**City of Portland, Maine – Building or Use Permit Application** 589 Congress Street, 04101, Tel: (207) 874-8703, FAX: 874-8716

## BUILDING PERMIT REPORT

**HOUSE SITE PLAN**  
 WEBB STREET  
 PORTLAND, MAINE

**RE:** Request for Certificate of Occupancy  
137 Webb Street (262-B-020)

**SITE PLAN**  
**A-1**

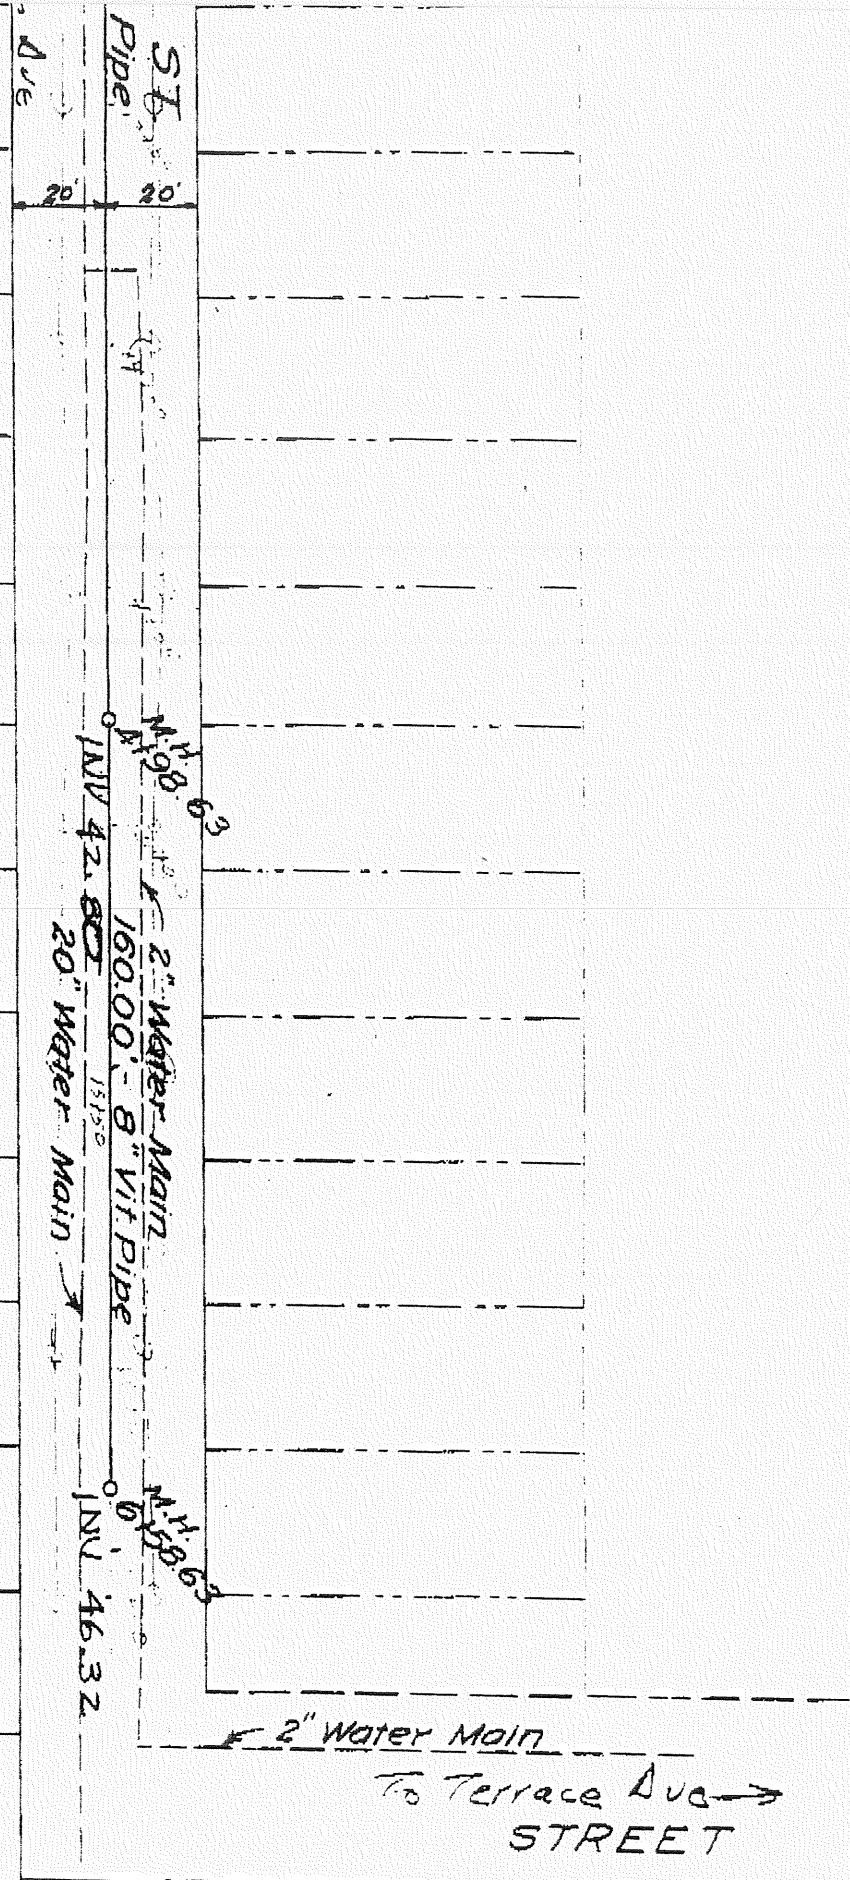
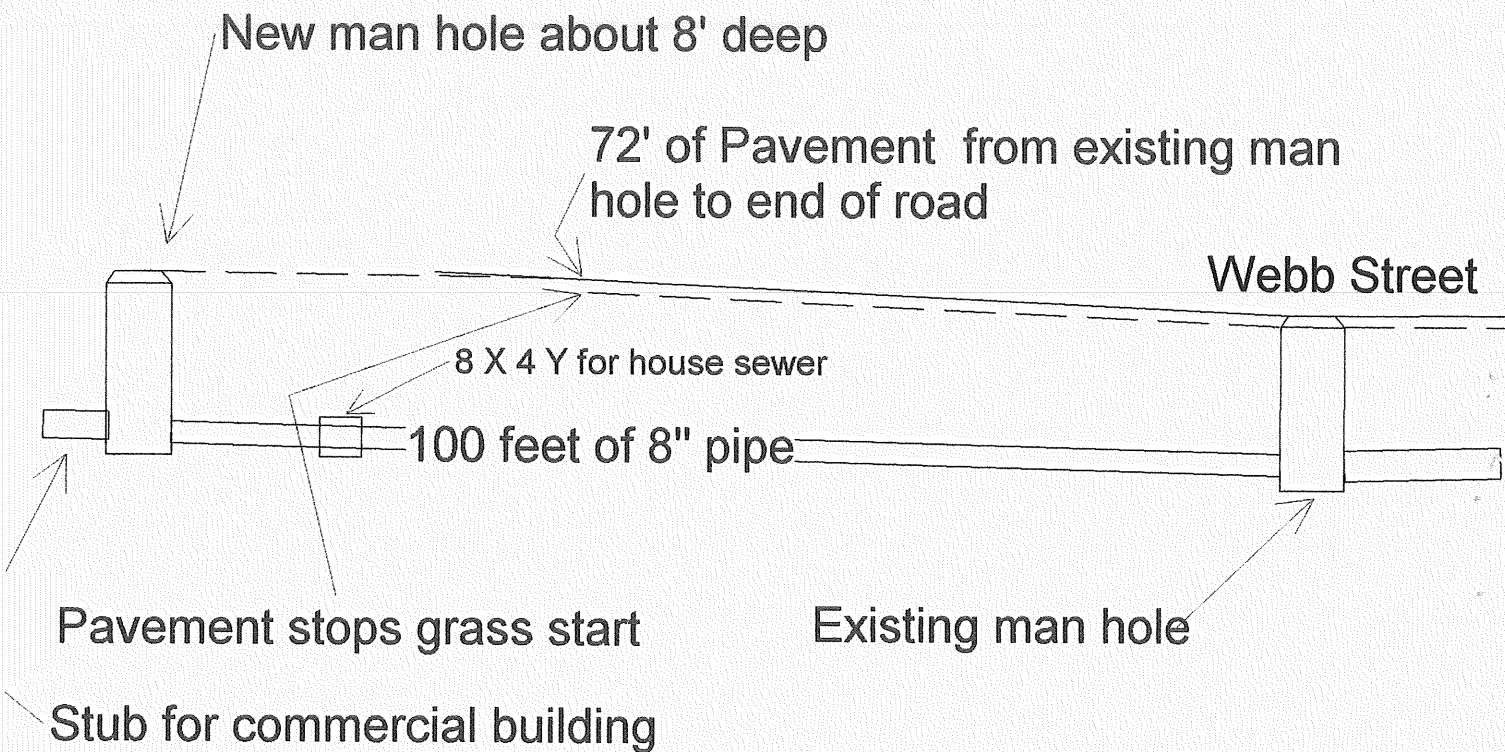
1. The street number needs to be placed on the house.
2. Final site grading and landscaping, including installation of two Portland accepted trees, have not been completed; given the time of year and the snow cover, the work should be delayed till spring but shall be completed by May 31, 1998. The applicant shall coordinate the work with the DRC prior to starting. The applicant shall note that the conditions of approval required that the drive within the right of way slope towards the street.

3. Public Works has indicated that they do not have ties and did not observe the sewer and storm service installations. Applicant is required to expose the services to the satisfaction of Public Works personnel; This work shall be coordinated with the final landscape work noted in item 2.

4. The original approval required a boundary survey; also a medium high retaining wall has been installed and the location of the services has changed. Therefore an "asbuilt" site plan must be submitted to the DRC showing the actual locations of the house relative to the property line based on the boundary survey, the utility services(i.e. sewer, water, storm and electric) and the retaining wall. The plan shall include the boundary survey information and the surveyor's stamp.

5. The applicant significantly disturbed abutting property. This area shall be repaired to the satisfaction of the property owner. Documentation in the form of a letter signed by the abutter that his property has been satisfactorily repaired is required. This work shall be coordinated with item 2.

It is my opinion that when items 1 and 4 are satisfactorily completed a **temporary certificate of occupancy could be issued** and assuming code enforcement has no outstanding issues. Items 2, 3 and 5 shall be completed by May 31, 1998.
